Illinois Tollway Standard Drawing Revisions

Section C	Guardrail / Median Barrier	
	Standard	**Modification Summary** **Effective: 03-31-2016**
	All	**The electronic (pdf) version of the Standard Drawing are now made searchable (text).**
	C1	**Galvanized Steel Plate Beam Guardrail**

GUARDRAIL INSTALLATION DETAILS

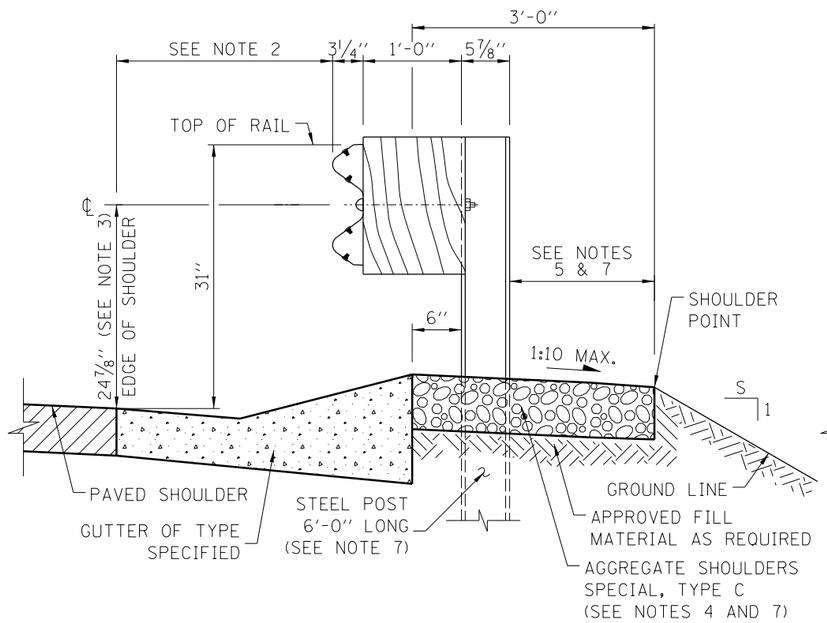
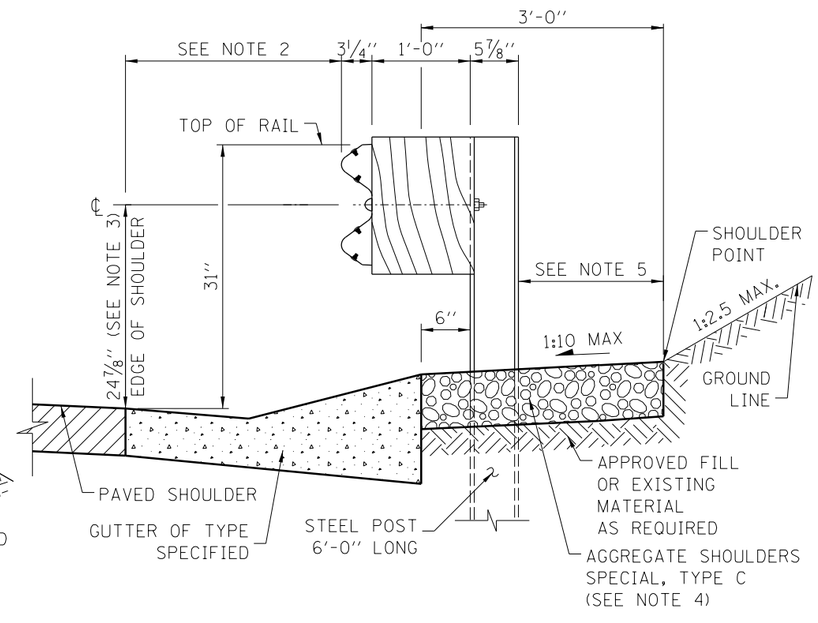
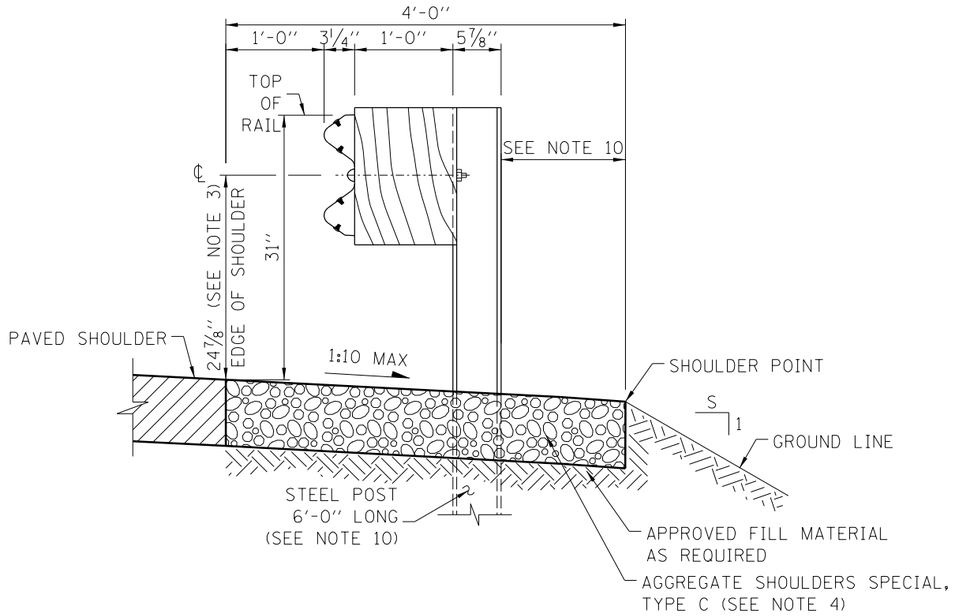
Sheet 1	Notes 5 & 7. Clarified aggregate shoulder width.
		Revised aggregate shoulder at shoulder point on sections to match base sheets. Added cut section with gutter.

DATE	REVISIONS
11-01-12	MODIFIED AGGREGATE SHOULDERS
03-31-14	REMOVED SECONDARY HOLE FROM POST AND UPDATED NOTES.
03-31-16	ADDED SECTION, REV'D SHLDR

SHOULDER WIDENING FOR TRAFFIC BARRIER TERMINAL, TYPE T1 (SPECIAL) TANGENT

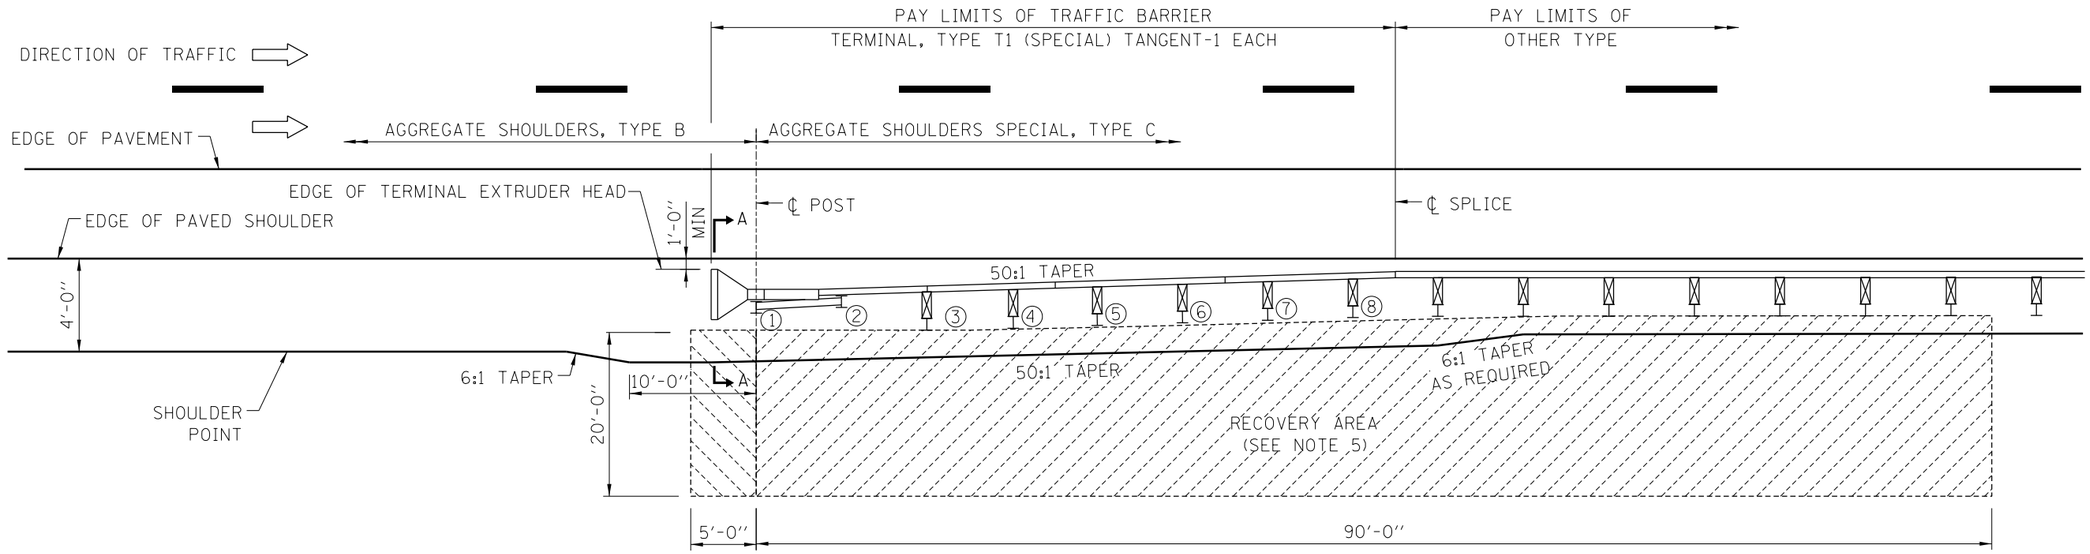
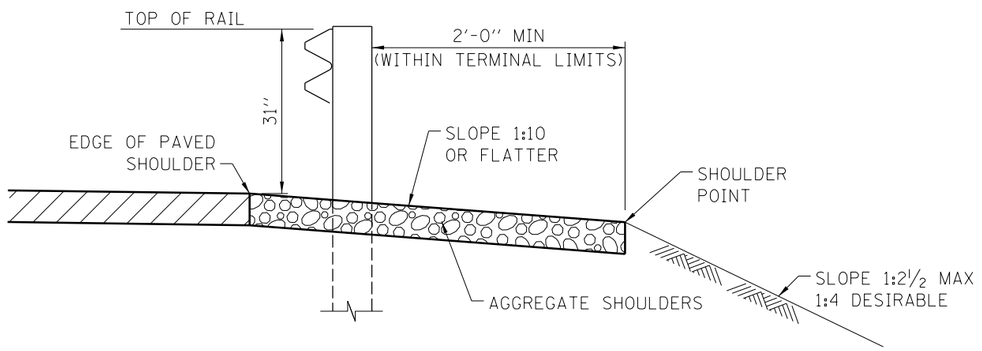
Deleted Sheet 3. Incorporated Gutter, Type G-2 into Sheet 2.
		Note 2. Added reference to minimum offset to rail.
		Note 6. Incorporated tangent and curved section notes into note 6.
		Revised Aggregate Shoulder in section to match base sheets. Revised Recovery Area so that 90' starts at Post 1.
		Removed minimum rail offset dimension in plan view.
	C7	**Traffic Barrier Terminal, Type T2**
		Revised Aggregate Shoulder in sections to match base sheets. Added edge of paved shoulder and
		shoulder point line to plan views.

DATE	REVISIONS
03-01-13	TERMINAL CHANGED TO ALL
	STEEL POST SYSTEM, REVISED
	TERMINAL PAY LIMITS
03-31-14	REVISED RECOVERY AREA
	DIMENSION
3-11-2015	REVISED NOTES
3-31-2016	COMBINED G-3 & G-2

TRAFFIC BARRIER TERMINAL, TYPE T2

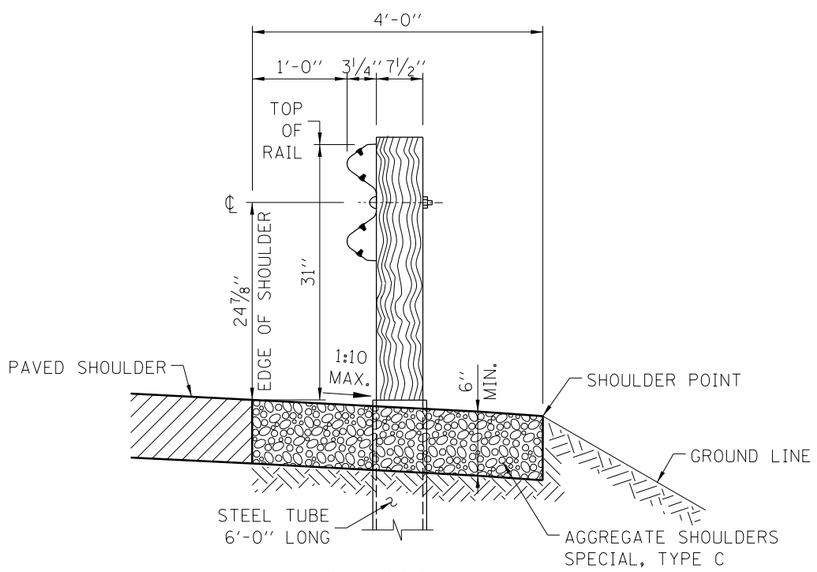
DATE	REVISIONS
2-07-2012	REVISED DIMENSIONS OF BEARING PLATE,
	POST, CABLE STRUT AND TUBE AND NOTES
11-01-2012	MODIFIED AGGREGATE SHOUILDERS,
	REVISED WOOD POST DIMENSION
3-31-2014	REVISED NOTES
3-11-2015	REVISED NOTES
3-31-2016	REVISED SECTION A-A SHOULDER

TRAFFIC BARRIER TERMINAL, TYPE T6

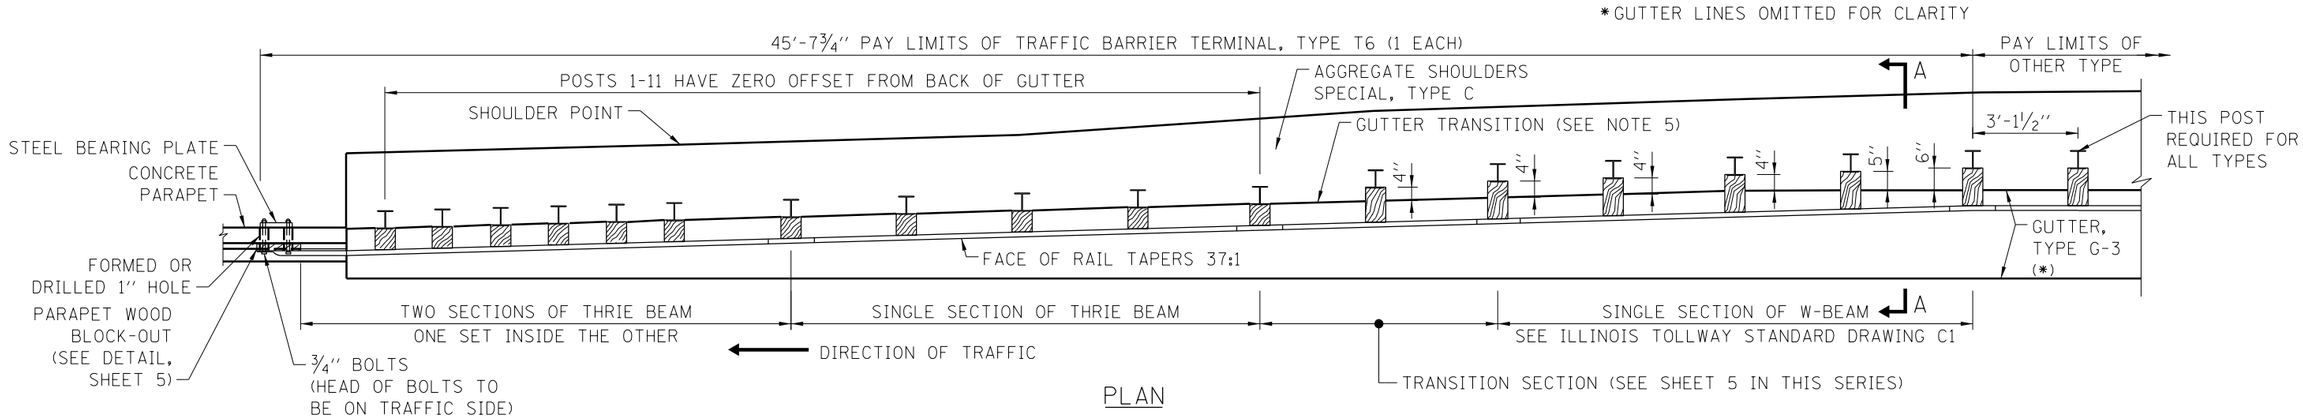
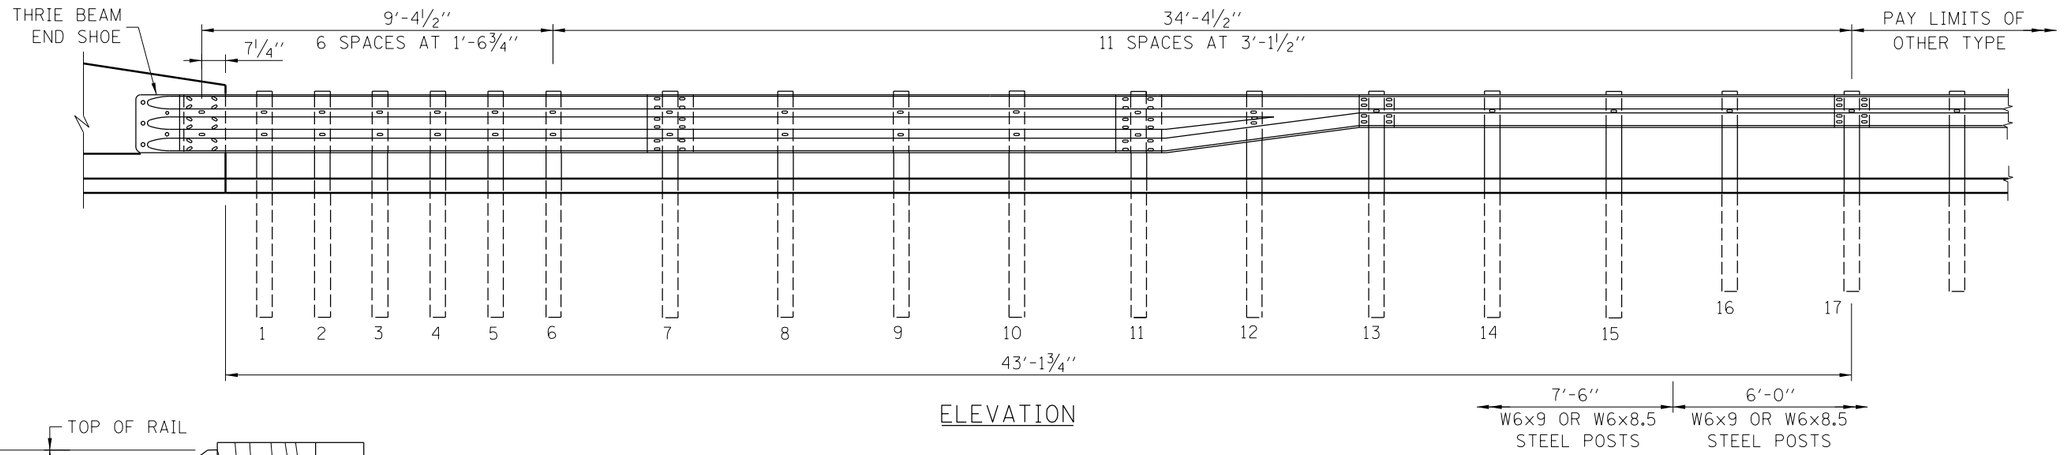
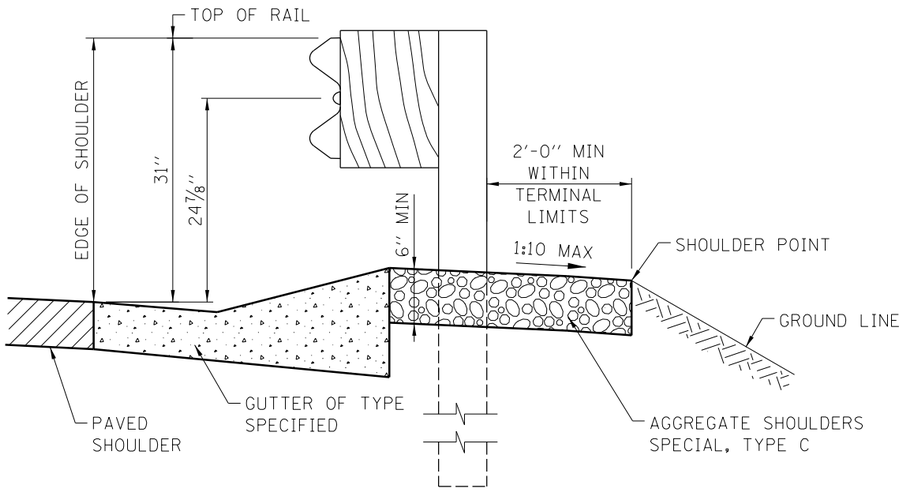
Sheet 3	Revised pipe diameter to 2" in Wood Post Detail
	C9	**Traffic Barrier Terminal, Type T6**
		Revised Aggregate Shoulder in sections to match base sheets. Added shoulder point line to plan views.
	C10	**Traffic Barrier Terminal, Type T6B**
		Revised Aggregate Shoulder in sections to match base sheets. Added shoulder point line to plan view.
	C11	**Traffic Barrier Terminal, Type T10**
		Revised Flared Wing angle from 15° to 20° (minimum), deleted note previously associated with it, and deleted 2' dimension
	C12	**Shoulder Widening for Traffic Barrier Terminal, Type T1-A (Special) Tangent**
		Note 3. Added reference to minimum offset to rail.
		Note 7. Incorporated tangent and curved section notes into note 7.
		Revised Aggregate Shoulder in sections to match base sheets. Revised Recovery Area so 65' starts at Post 1.
		Removed minimum rail offset dimension in plan views. Removed Gutter, Type G-3 Row in Table 1.

DATE	REVISIONS
2-07-2012	REVISED BOLT NOTES, ANCHORAGE ADHESIVE AND REVISED NOTES.
11-01-2012	MODIFIED AGGREGATE SHOULDERS, REVISED NOTES.
3-31-2014	REVISED NOTES.
3-11-2015	REVISED NOTES AND ADDED DETAIL.
3-31-2016	REVISED SHOULDER SECTION

TRAFFIC BARRIER TERMINAL, TYPE T6B

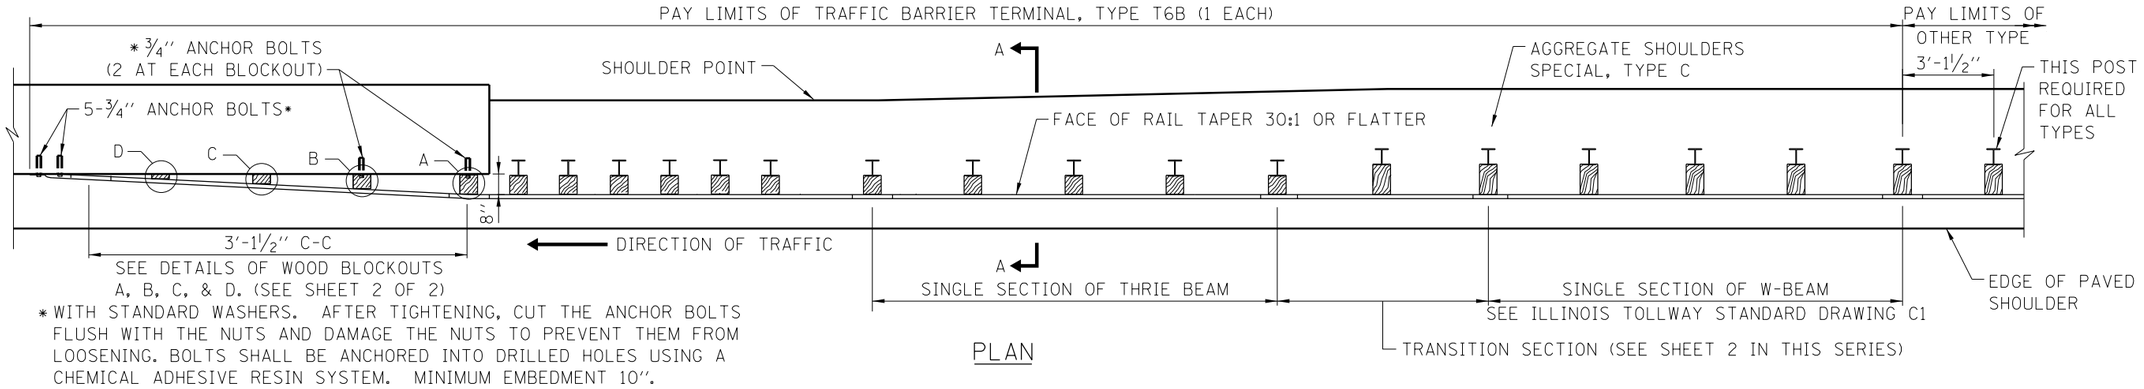
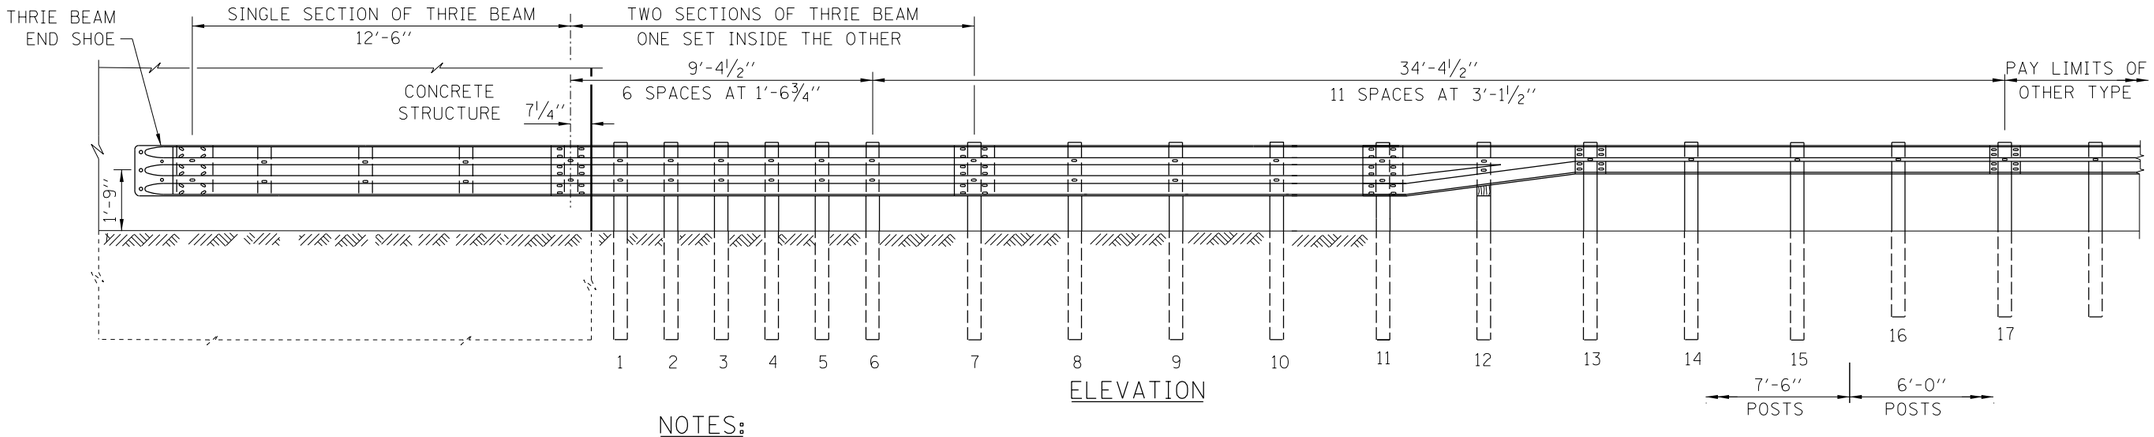
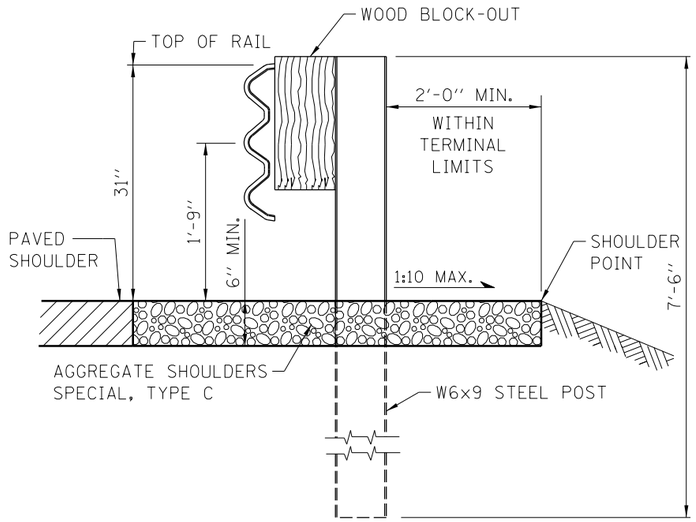
DATE	REVISIONS
2-07-2012	REVISED WOOD BLOCK-OUT DIMENSION
	ADHESIVE AND REVISED NOTES
11-01-2012	MODIFIED AGGREGATE SHOULDERS.
	REVISED NOTES
3-31-2014	REVISED WOOD BLOCKS AND NOTES
3-11-2015	REVISED NOTES
3-31-2016	REVISED SECTION A-A SHOULDER

SHOULDER WIDENING FOR TRAFFIC BARRIER TERMINAL, TYPE T1-A (SPECIAL)

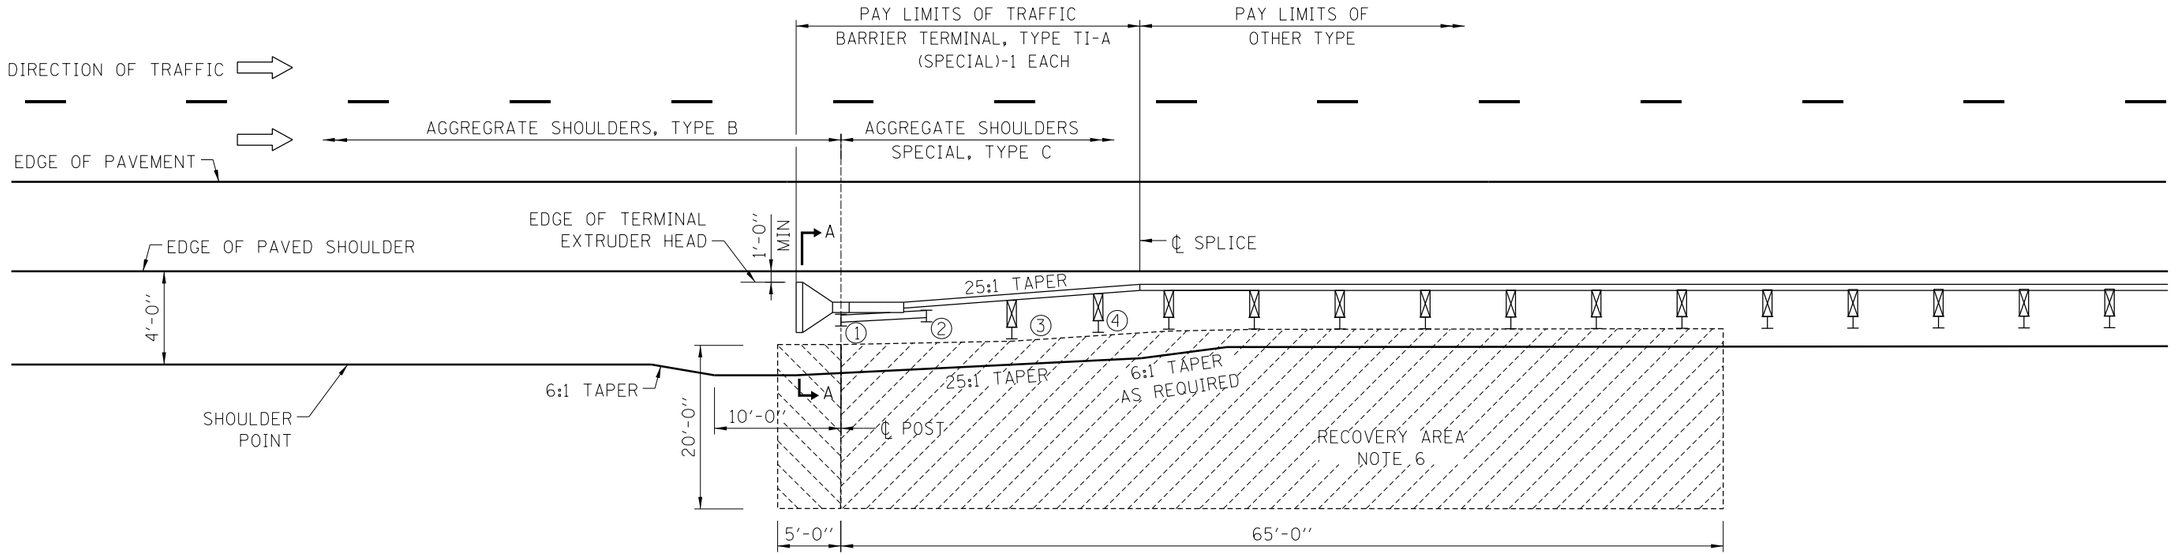
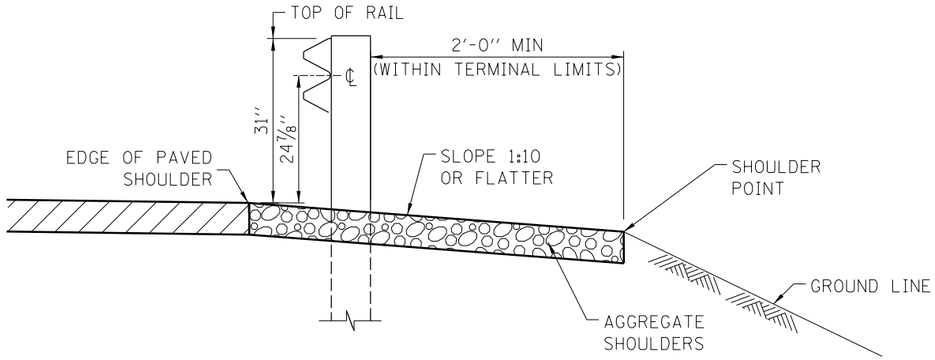
DATE	REVISIONS
2-07-2012	REVISED SLOPE NOTE.
11-01-2012	MODIFIED AGGREGATE SHOULDE
3-01-2013	TERMINAL CHANGED TO ALL STEEL POST.
	REVISED TERMINAL PAY LIMITS
3-31-2014	REVISED RECOVERY AREA DIMENSION.
3-11-2015	REVISED NOTES
3-31-2016	ADDED INSTALLATION NOTES IN NOTE 7
	AND REVISED SECTION A-A SHOULDER
